RE: 15 & 17 Elm Street

1.0 INTRODUCTION

8.1 DEVELOPMENT ENGINEERING COMMENTS – MEMORANDUM DATED NOVEMBER 28TH, 2022 – TRANSPORTATION SERVICES COMMENTS

| | Drawing No. VMD-01 | |

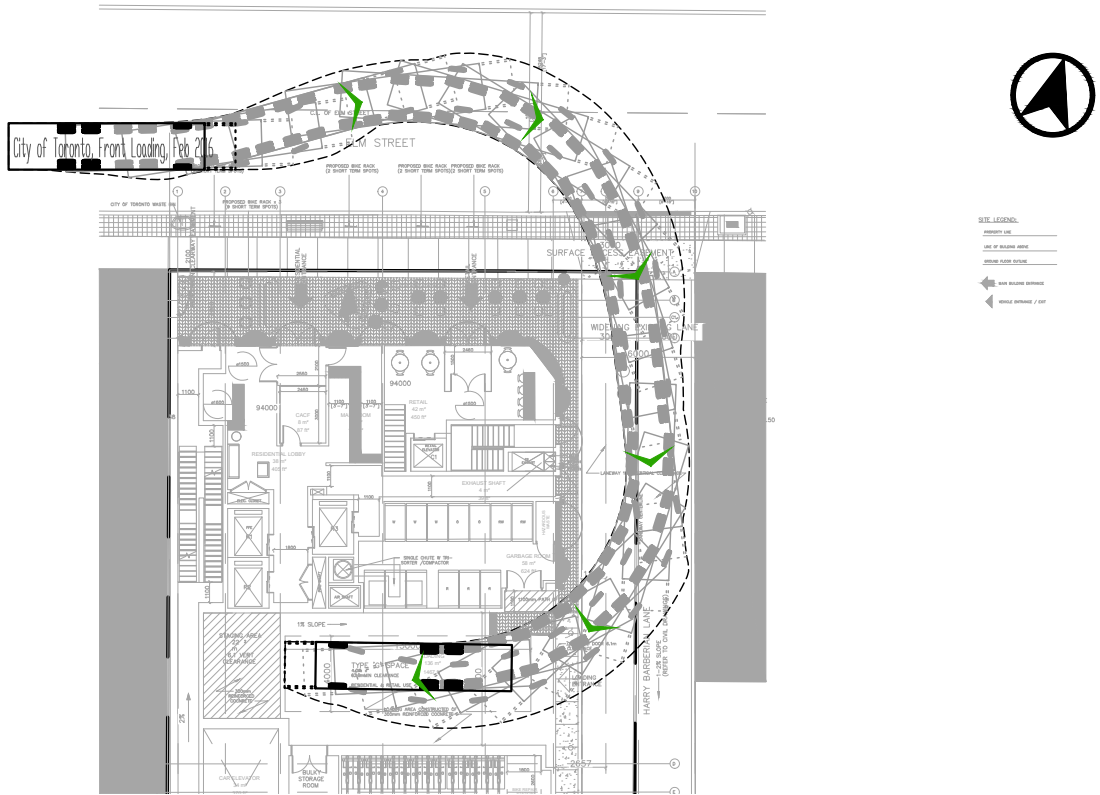
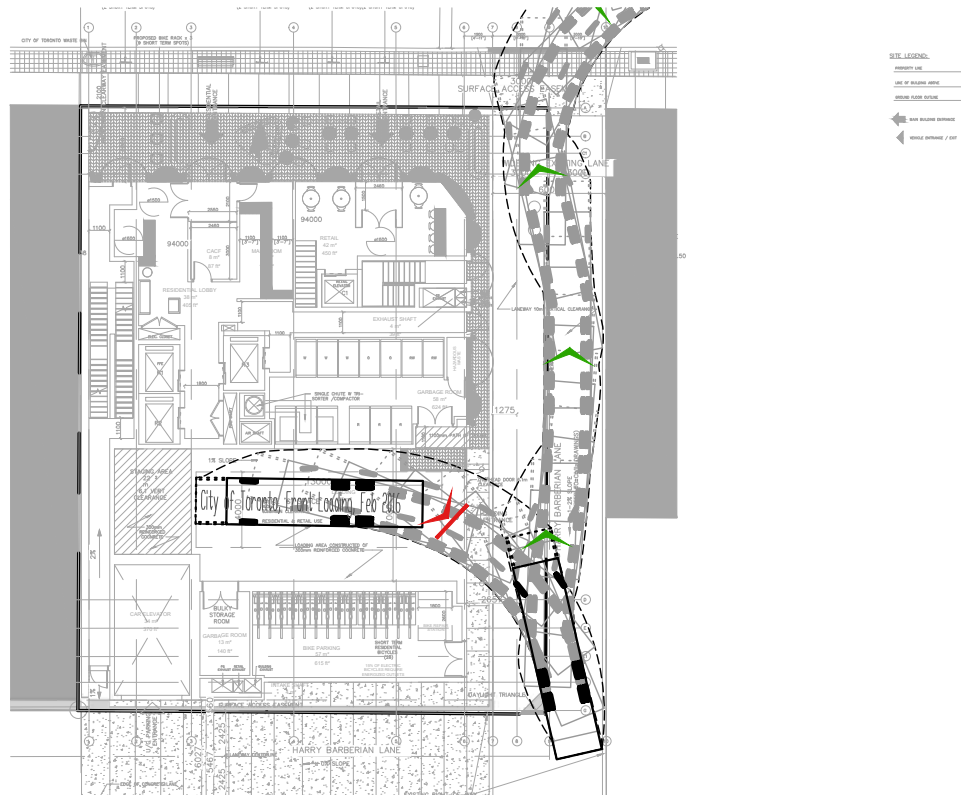
Provide a warning system to alert drivers, cyclists, and pedestrians within the public laneway that large trucks are manoeuvring on-site and provide documentation on the type of warning system used and how it will be activated.

The planned movement of the collection vehicle is adjacent to entrance/exit from the parking garage revised drawings must indicate a warning system to caution motorists leaving the parking garage of heavy vehicles when loading operations are occurring. This warning system should include both lights and signs.

Detailed vehicle maneuvering diagrams illustrating a City of Toronto refuse collection vehicle, TAC 'Heavy Single-Unit' (HSU), and TAC 'Single Unit' (SU) accessing these loading spaces by entering and exiting the site in a forward motion are provided in **Appendix B**.

Due to the condition of city trucks reversing into the public lane, the following conditions are proposed:

- On-site staff to be available assist as flagmen for the City vehicle on collection days
- Warning signage on laneway with flashing beacons to warn motorists in the laneway that trucks are manoeuvring ahead.
